Review of Proposed Route 29 Bypass and Berkmar Drive Extended

Michael J. Wallwork, P.E.
Prepared for Southern Environmental Law Center
July 25, 2001

Figure 1A. Shared bridge and one long, skewed bridge over the Bypass ramps

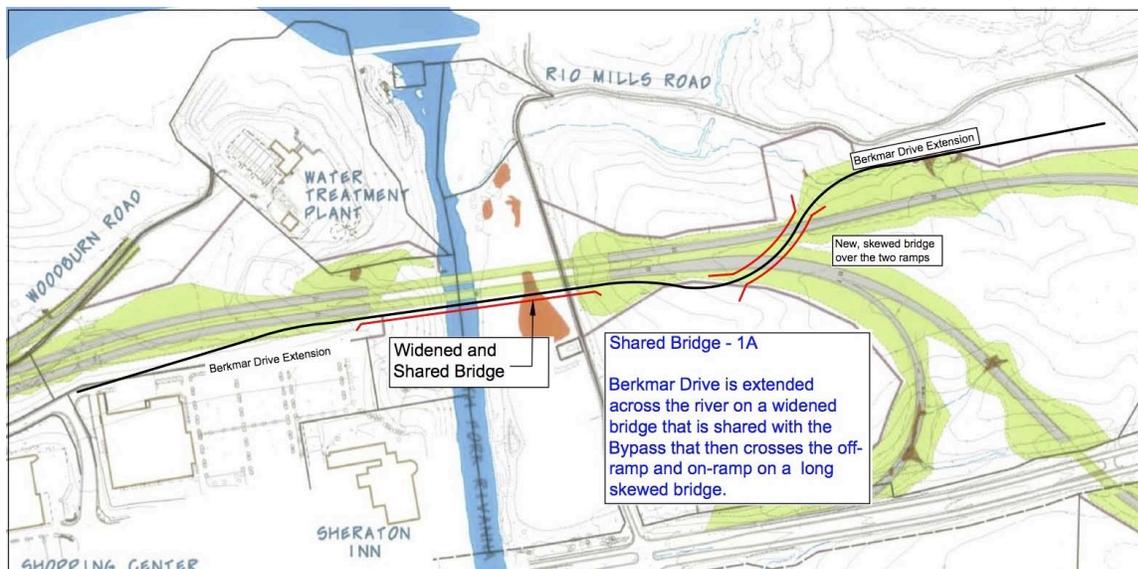
Once Berkmar Drive traffic has crossed the river on the shared bridge, it must then cross an off-ramp and then an on-ramp of the Bypass. To do so would require one long, skewed bridge over the two ramps as shown in Figure 1A, for a total of two bridges including the bridge over the River. Alternatively, the Berkmar Drive extension could swing out to the east and cross the ramps closer to 90 degrees using two shorter bridges as shown in Figure 1B, for a total of three bridges for the project.

Notably, because Berkmar Drive is next to the Bypass, under the shared bridge option, it would be impossible to connect Berkmar Drive to the Bypass. Further, to raise the level of Berkmar Drive from the shared bridge to the overpass across the Bypass off-ramps -- only about 280 feet away -- would require a fairly steep grade of around 8 percent or greater, which may be unacceptable.

Figure 2A. Two interchanges using underpass on south side and Rio Mills Road on the north side of the River.

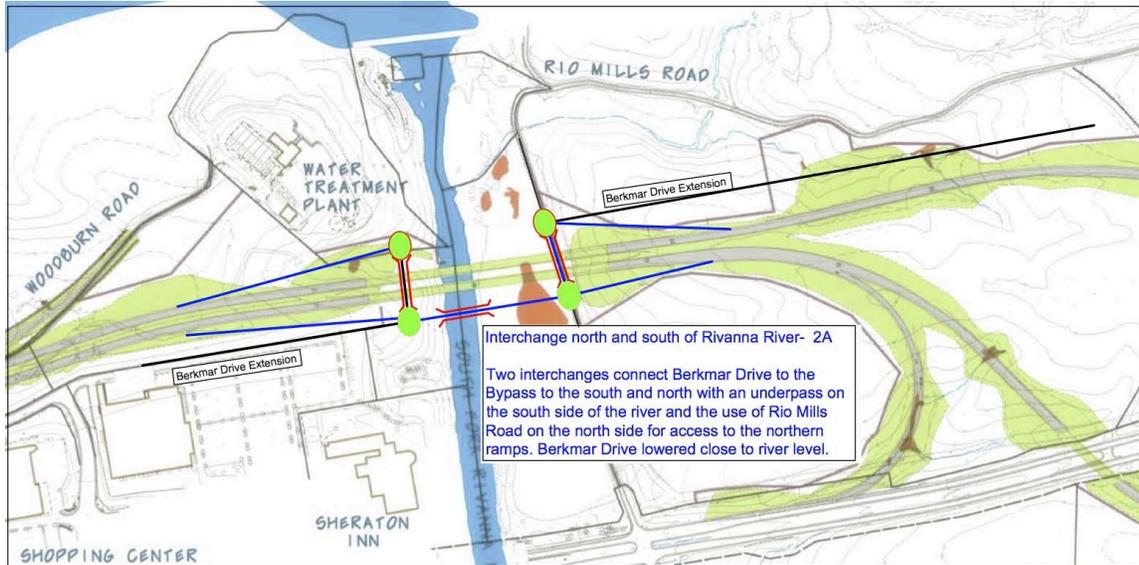
Figure 2A provides for an underpass on the south side of the river with two roundabouts to minimize the footprint of the interchange and to minimize the right-of-way that would need to be taken. This option requires a bridge under the bypass on the south side, a separate river crossing, and the use of Rio Mills Road on the north side, with an interchange to connect the two roads as shown in Figure 2A. Utilizing this design enables Berkmar Drive to cross to the other side of the Bypass and continue northwards to Hollymead Town Center without the need for separate bridges over the Bypass ramps. Although this option uses a much smaller footprint than the overpass option shown below, Berkmar Drive would have to be lowered about 23 feet below the Bypass to provide the necessary vehicle clearance. Because of lack of elevation information, and in particular information on the river levels and their variation, it was not possible to determine if an underpass would be affected by variations in water level in the river and whether or not it could be subject to flooding and in need of flood protection.

Figure 2A below shows two bridges: an underpass bridge of the Bypass on the south side of the River and a separate bridge over the River.

Figure 2B. Interchange on north and south sides of River using overpass

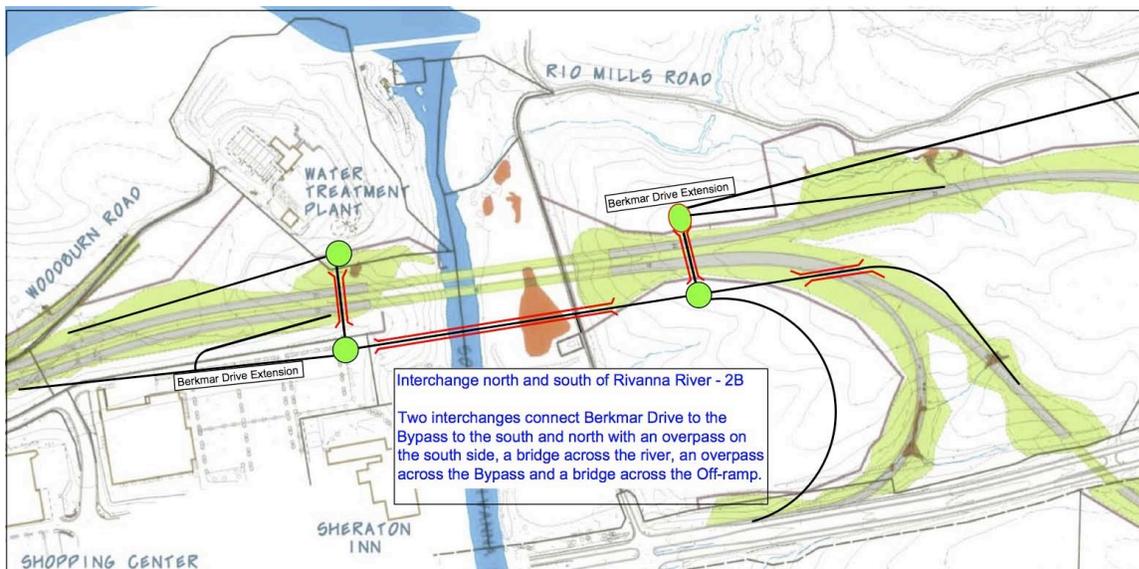
Figure 2B below shows a sample interchange design using overpasses to span the Bypass. It would require three overpass bridges and a long bridge across the river.

Because an overpass would require extensive ramps to provide access to the Bypass, extensive right-of-way would be required that would have significant effects on developed properties, including Lowes, the water treatment plant and other properties.

Figure 3A uses two long bridges

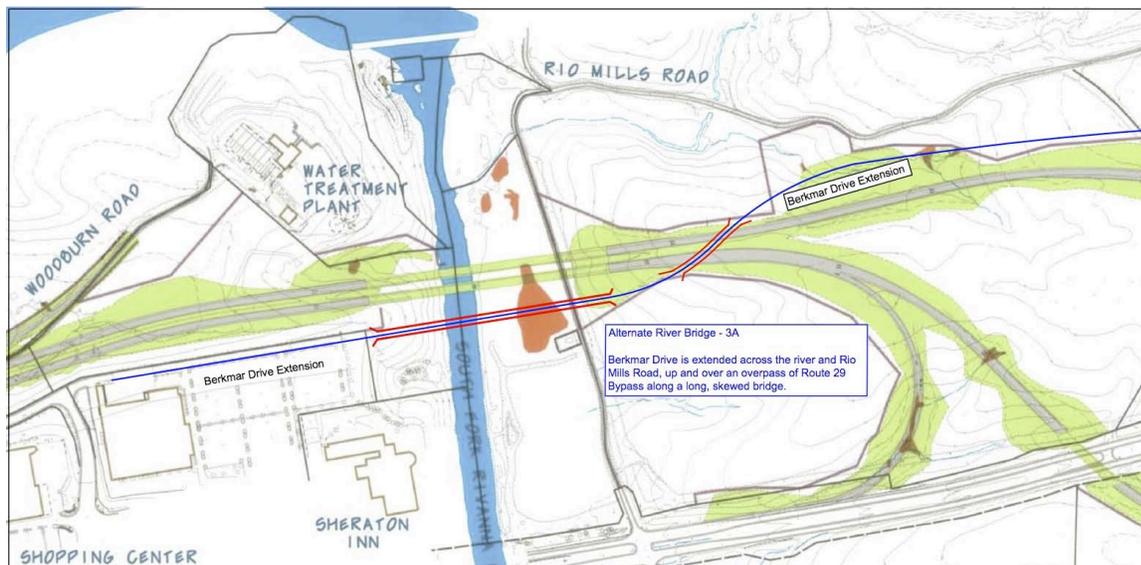
The suggestion has also been made that Berkmar Drive could be extended northwards across the River on a separate bridge that rises up to an overpass ramp across the Bypass off-ramp and then continues on and over the Bypass on-ramp on another bridge as shown in Figure 3A.

Both concepts require one long river bridge, and either one long overpass bridge or two short overpass bridges over the Bypass ramps. Also, both options are problematic and very expensive. 3B would also use extensive land area for ramps leading to overpasses. Alternatively, underpasses rather than overpasses could be used, requiring the same length bridges, but necessitating extensive cuts rather than fill.

Figure 3B uses one lane and two short bridges

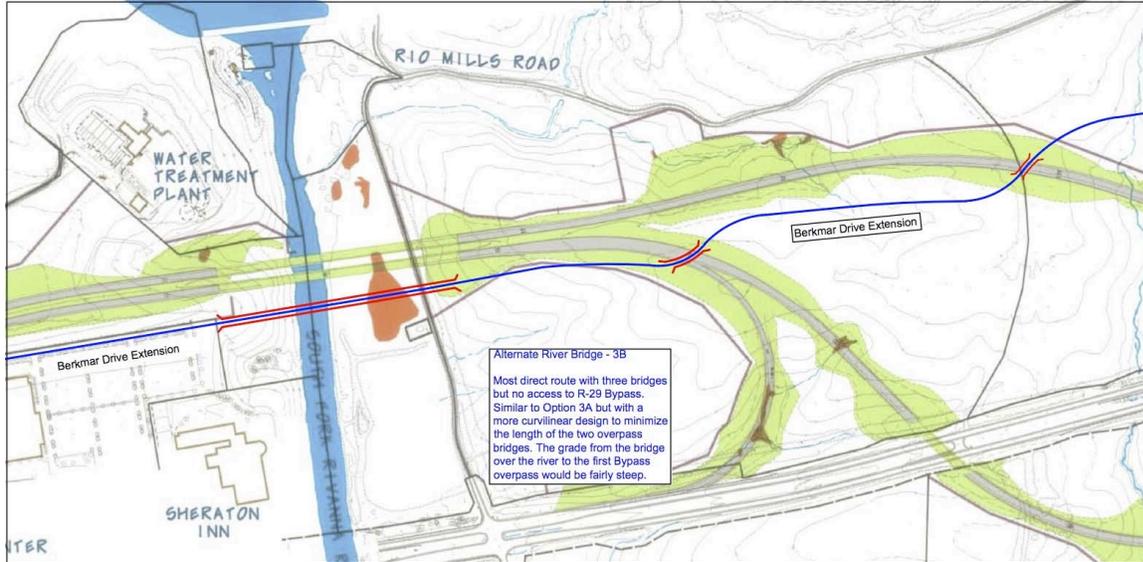
Alternatively it could curve away from the Bypass and cross the two ramps at an angle closer to 90 degrees, and so shorten the length of the two overpass bridges as shown in Figure 3B.
